**Committee of Experts on the Transport of Dangerous Goods
and on the Globally Harmonized System of Classification
and Labelling of Chemicals**

Amendments to chemicals under pressure and aerosols

Transmitted by the expert from Germany

Table 2.3.2 Criteria for chemicals under pressure

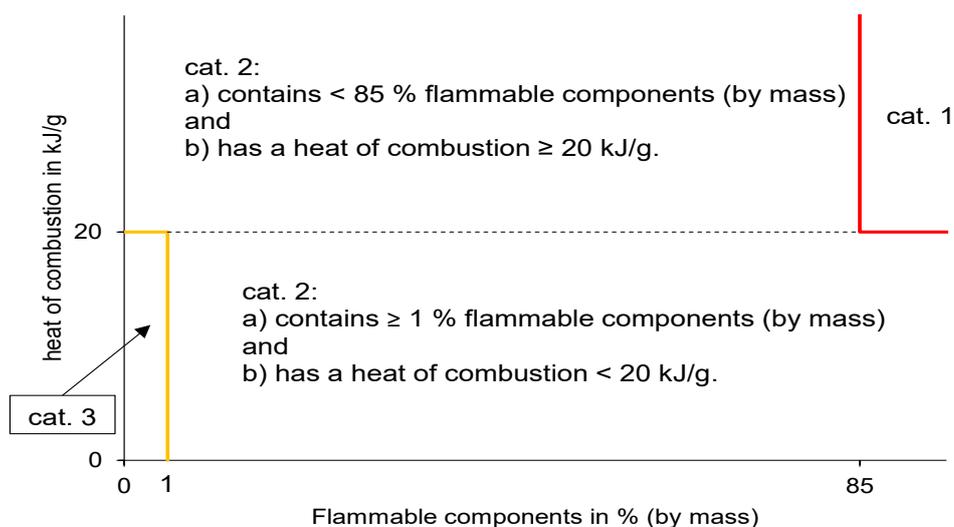
Replace sections 2.3.2.2.1 to 2.3.2.2.4 by the following (amendments are underlined, deletions are not shown in order to be better legible):

Every physical hazard class (except chapter 2.8 and 2.15) contains a criteria table (for aerosols it is supposed to be introduced with ST/SG/AC.10/C.4/2018/9). It is therefore suggested to introduce a criteria table for chemicals under pressure as well. The contents of that criteria table would reflect what currently is proposed for sections 2.3.2.2.2 to 2.3.2.2.4. These paragraphs therefore are no longer needed and the presentation of the criteria then would be in line with how the criteria are usually presented in the GHS.

The added wording of the criteria for category 2 becomes clear with the following chart:

<u>Category</u>	<u>Criteria</u>
1	Any chemical under pressure that a) contains $\geq 85\%$ flammable components (by mass) and b) and has a heat of combustion of ≥ 20 kJ/g.
2	Any chemical under pressure that a) contains $\geq 1\%$ flammable components (by mass) and b) has a heat of combustion < 20 kJ/g or that a) contains $< 85\%$ flammable components (by mass) and b) has a heat of combustion ≥ 20 kJ/g.
3	Any chemical under pressure that a) contains $\leq 1\%$ flammable components (by mass) and b) and has a heat of combustion of < 20 kJ/g."
